**RECALL CAMPAIGN
INSTRUCTIONS**

REF. NO. C24100080

**REPLACEMENT OF BRAKE FLUID
RESERVOIR CAP**

MODEL YEARS 2005 - 2009

New Adhesive Sticker

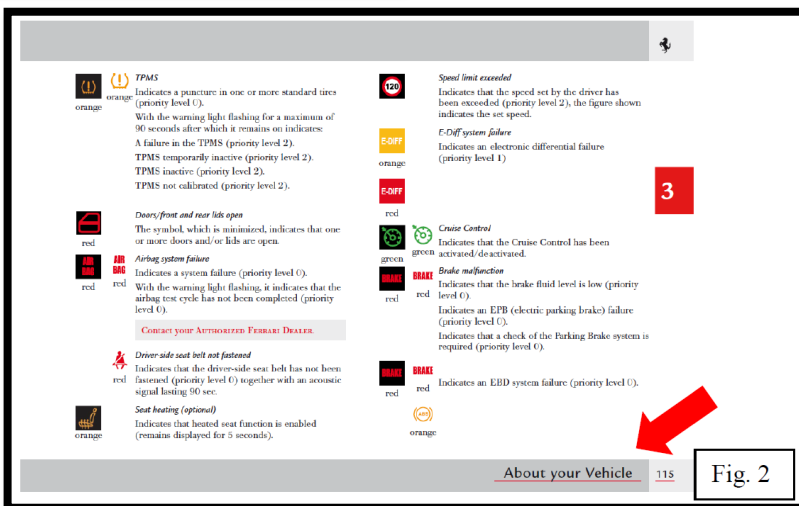
Please find below the proper location and instructions on how to insert the provided sticker into the Owner's Manual (PN: 079641778)

The sticker must be placed on the page shown above in the Owner's Manual. This page is located in the **"About Your Vehicle"** section where the warning lights on the instrument panel are described. Please be sure to attach it to the page with the **"Low Brake Fluid"** description as shown above in Fig. 2.

Once you locate the proper page, remove the adhesive protector off of the back of the sticker. Ensure there is no residue or other particles on the page that may inhibit the longevity of adhesion to the page. Place the sticker to allow the bottom of the sticker to lay directly above the gray margin at the bottom of the page that contains the text **"About your Vehicle"**.

Once applied, apply pressure across the whole strip of 'glue' to confirm the sticker has been properly mated to the page.
